Office Action Summary

09/955,948

TATSUNO ET AL.

FIG. 23

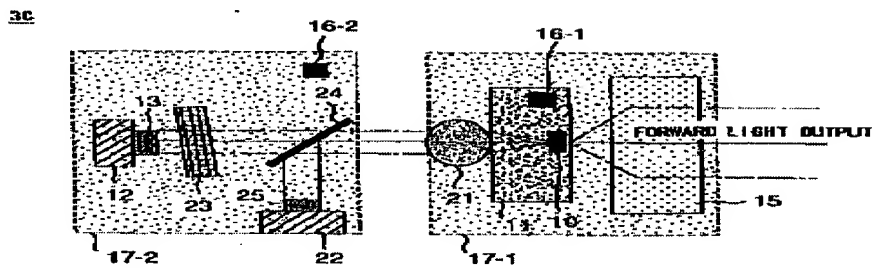
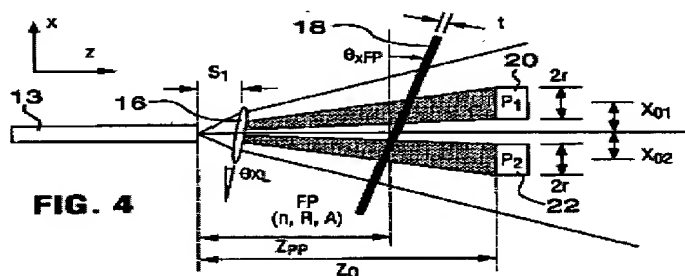
Figures 22 and 23 illustrates an optical module having a laser source (10), an output forward laser beam and back facet monitoring laser beam. The monitoring laser beam is divided by beam splitter (24) into two portions beams, where one portion is detected by photodetector (25), a second portion is filtered by etalon (23) and transmitted to photodetector (13), where the optical components of the module are positioned on mount carriers (17-1) and (17-2), which mounted on TEC (14-2) for temperature control of the optical module. Figure 24 illustrates the feedback circuit of the optical module, which makes the necessary temperature adjustment in accordance to the compared signals received by the photodetectors.

Figures 22 and 23 illustrates an optical module having a laser source (10), an output forward laser beam and back facet monitoring laser beam. The monitoring laser beam is divided by beam splitter (24) into two portions beams, where one portion is detected by photodetector (25), a second portion is filtered by etalon (23) and transmitted to photodetector (13), where the optical components of the module are positioned on mount carriers (17-1) and (17-2), which mounted on TEC (14-2) for temperature control of the optical module. Figure 24 illustrates the feedback circuit of the optical module, which makes the necessary temperature adjustment in accordance to the compared signals received by the photodetectors.

FIG. 11

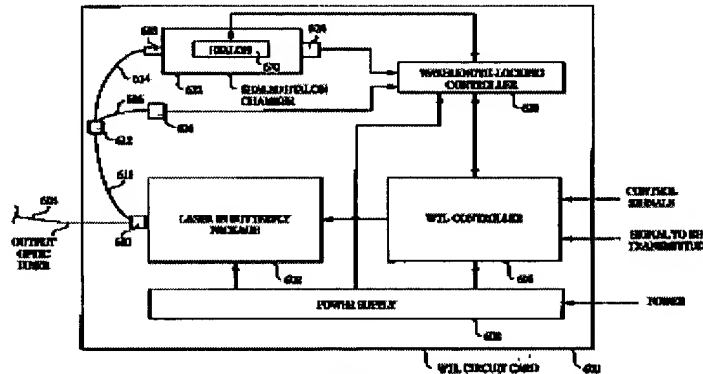
May discloses in paragraph [0056] and illustrates in figure 11, providing an enclosure (622) for the etalon (62), which will control the temperature of the etalon and maintain the temperature of the etalon similar to the laser source.

May discloses in paragraph [0056] and illustrates in figure 11, providing an enclosure (622) for the etalon (62), which will control the temperature of the etalon and maintain the temperature of the etalon similar to the laser source.
